Downtown Code Design Review Committee

Meeting Minutes

January 9, 2020

2) Canopy-Homewood

Figure 7: NES Handbook Diagram

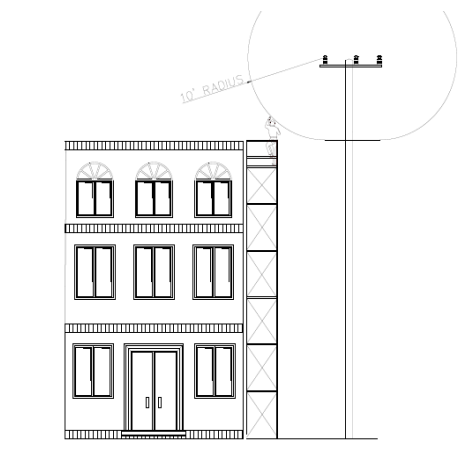
The build-to zone along Overton Street is 0-10 feet from back of sidewalk for a minimum façade width of 60% of the lot frontage. The proposed massing yields a building that is approximately 15 feet from the back of sidewalk for over 60% of the lot frontage. The stated intent of this request is to allow the building to meet OSHA working clearances promulgated by the NES Customer Handbook. In this case, there are existing power lines on both Division Street and Overton Street.

The intent of this standard is to allow buildings to foster a close relationship with streets and activate ground-level spaces. In this case, the northern portion of this frontage serves as the primary entry for the hotel and the southern portion of this frontage will feature outdoor dining areas and public art. The proposed plan balances urban design outcomes with practical life-safety needs.

Figure 8: Building Massing at Division Street Frontage

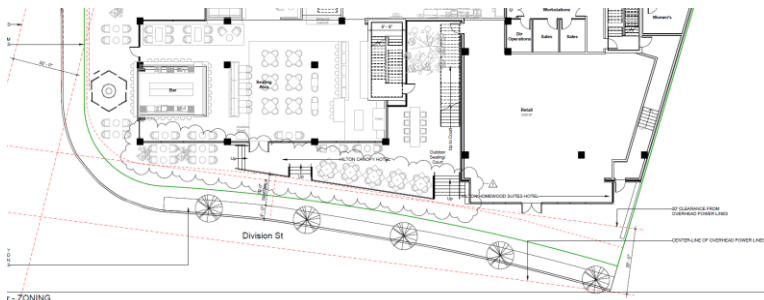
The build-to zone along Division Street is 0-10 feet from back of sidewalk for a minimum façade width of 80% of the lot frontage. In this case, while portions of the building are within the build-to zone, the minimum façade width is approximately 52% of the lot frontage. Like the condition on Overton Street, Division Street is also encumbered by power lines and the massing has been articulated in a way that avoids the life-safety issue described previously. The remaining 48% of the lot frontage will be programmed and activated exterior space, with outdoor seating and seating proposed. Due to the activity proposed along this façade and the exterior dining areas, we find that the frontage is appropriately activated and recommend approval of this modification.

Figure 9: Division Street (Left) and Overton Street (Right) Sections

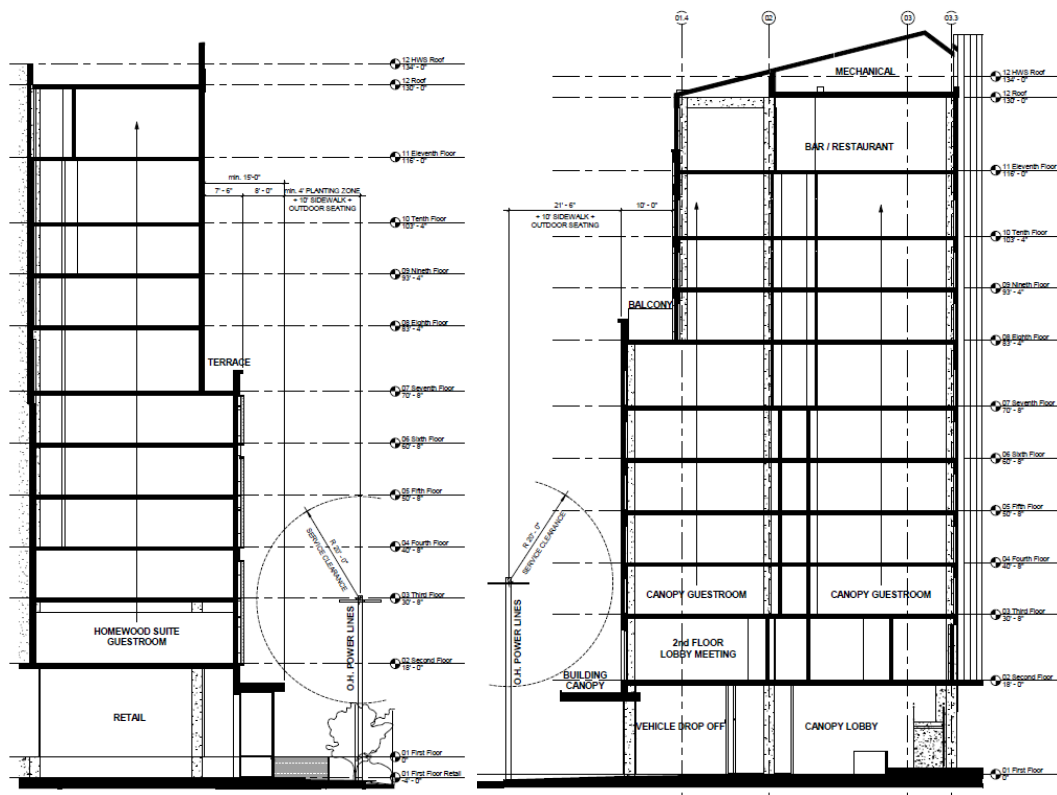
The DTC requires buildings seven stories or greater to step back 15 feet between the fourth and eighth stories. The step-back is measured from the façade of the building. The project proposes stepping back 10 feet on Overton, rather than 15 feet. Along Division, the building steps back 7' at the 2nd story and 8' at the 7th story.

The intent of the step-back standard is to allow light and air to permeate to the street by pushing upper levels of the building back from the street. In this case, the proposed massing yields an equivalent effect on light or air permeating to the street. On Overton Street, rather than being built at 10 feet from the back of sidewalk with a 15-foot step-back, the building is proposed at 15 feet from back on sidewalk with a 10-foot step-back. On Division Street, the step-back is broken up, with a 7' portion of the step-back occurring at the 2nd floor (as opposed to the 4th floor) and the remainder of the step-back occurs at the 7th story. Both of these fulfill the basic intent of the standard in the context of the encumbrances along these frontages. Taking into consideration the merits of the massing and the intent of the step-back standard, staff is supportive of this modification.

Ash Street Frontage Section

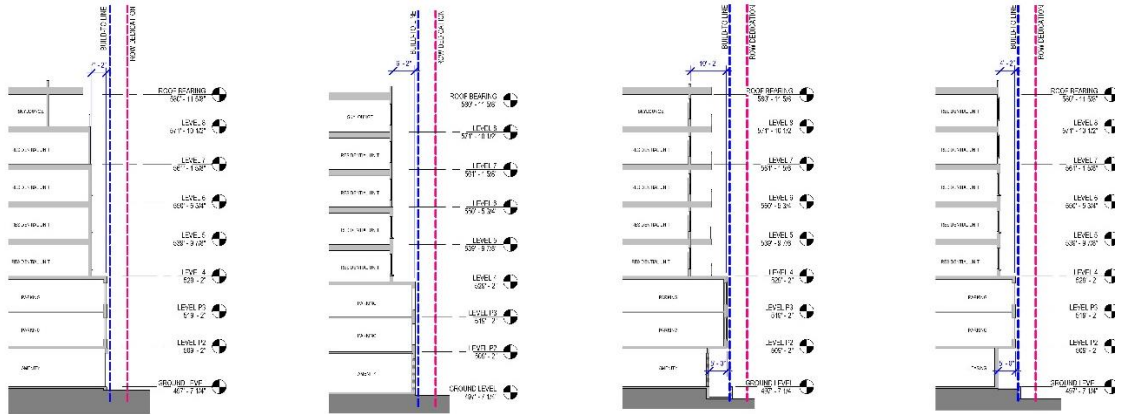
The DTC requires buildings seven stories or greater to step back 15 feet between the fourth and seventh stories. The modification along 3rd Ave South, 4th Ave South, and Lafayette Street is to permit a step back at the fourth story that ranges from approximately two to four feet and up to eight feet for façade at the location of balconies. The modification along Ash Street is to permit a step back at the fourth story that ranges from approximately four to six feet and up to 10 feet for the façade at the location of balconies.

Lafayette Street, 3rd Ave South, 4th Ave South Frontage Sections

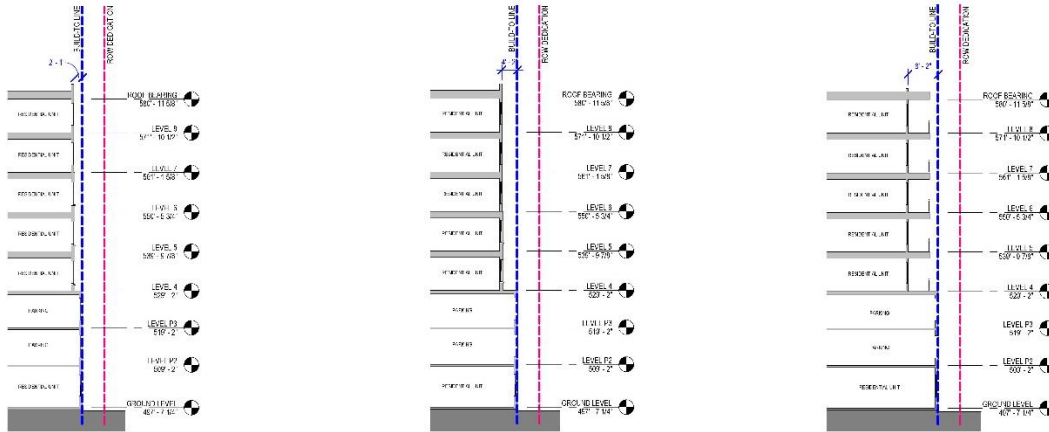
The applicant has worked with planning staff on the design of the building, including fenestration patterns, articulation of building materials, garage screening, building sections, building orientation, vehicular access, and pedestrian access. Staff is now comfortable recommending approval to the step-back modifications for this design. The mass of the building does not feel overwhelming to these streets due to partial step-backs, the presence of balconies, the façade articulation, and the material changes.
